**OHIO TURNPIKE AND
INFRASTRUCTURE COMMISSION**

ADDENDUM NO. 2

PROJECT NO. 43-19-07

BRIDGE REHABILITATION AND 3RD LANE WIDENING
OHIO TURNPIKE OVER AI CREEK M.P. 47.4,
OHIO TURNPIKE OVER S.R. 64 (N. MAIN ST.) M.P. 47.5
MILEPOST 46.50 TO MILEPOST 50.92
FULTON AND LUCAS COUNTIES, OHIO

8 / 349

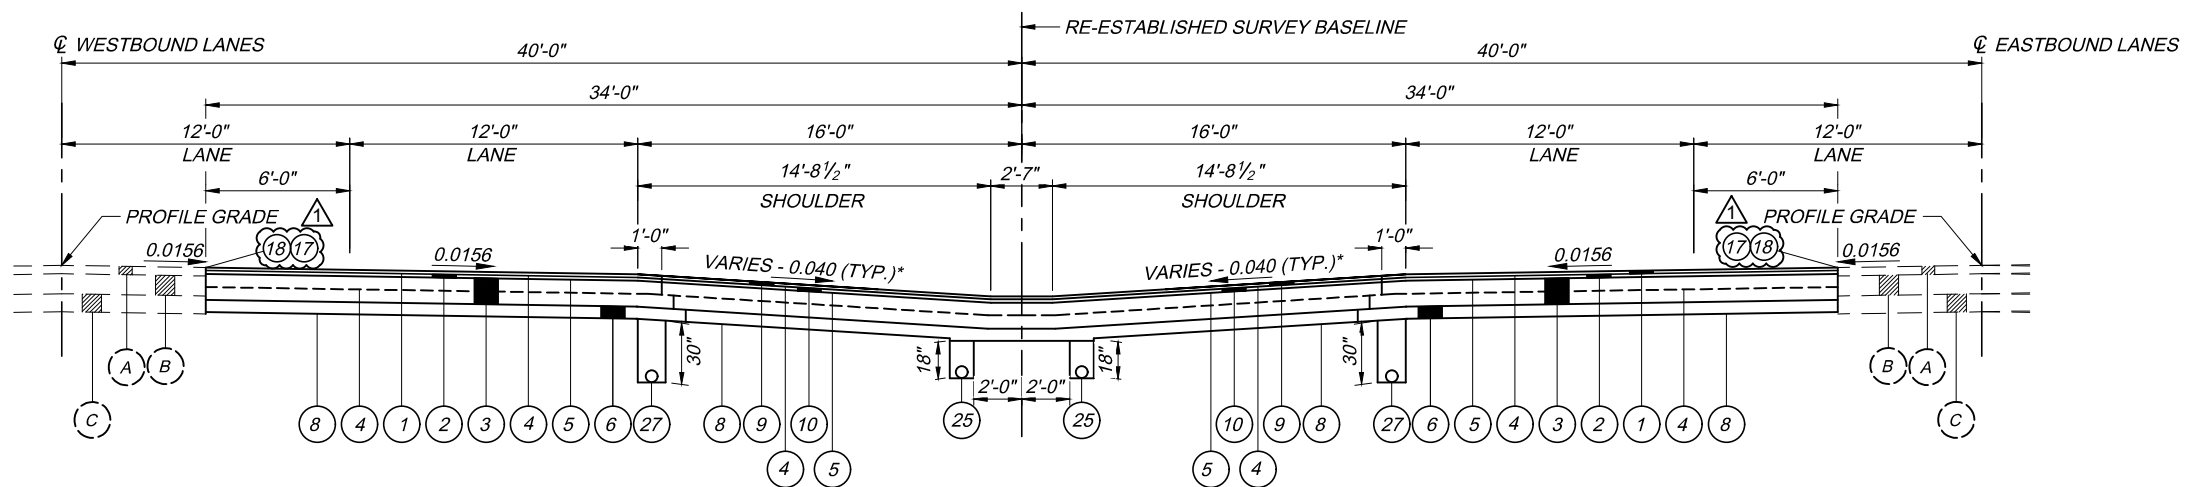
Q#19 SP404A Joint Sealer is calculated for only 1 length of both Westbound & Eastbound. The note on sheet 8 of the Typical Sections say it is to be applied to the vertical face of both the SP402 & SP402 and the SP404A in the Special Provisions say to apply it to all cold longitudinal joints. Will this item be paid for each application of the joint sealer or will it be paid only for the length calculated regardless of how many cold longitudinal joints are placed (between lanes/shoulder, phase joints, etc.)?

A#19 The Commission revises Plan Sheets 8, 9 and 11 of 349 through this Addendum No. 2 to add Balloon 17, SP 404A – Joint Sealer to all vertical faces created by a saw cut. The item will be paid only for the calculated length of the vertical face regardless of the number of pavement courses placed adjacent to it. No quantity revisions are required as a result of this revision.

- 17 SP 404A JOINT SEALER (APPLIED TO VERTICAL FACE, SP 402 AND SP 404)
- 18 ITEM 252 FULL DEPTH PAVEMENT SAWING
- 19 ITEM 659 TOPSOIL (T=3")
- 20 ITEM 209 LINEAR GRADING, AS PER PLAN
